**CONCLUSION TO MAY 2018
URGENT MEDICAL DEVICE CORRECTION**

Medtronic HeartWare™ HVAD™ System – Power Source Lubricant Servicing

October 2019

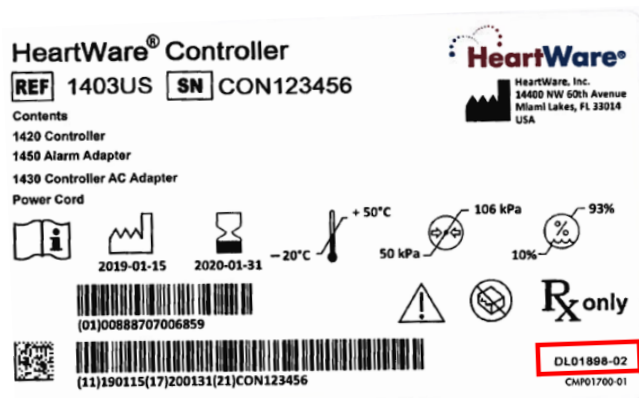
Controller Kits (Models 1400, 1401, 1403, 1407) containing an AC Adapter (Model 1425 or 1430) that are lubricated **during manufacturing** are identified by device label number, **DL01898-02**, as shown by location of the red box on the packaging label below.
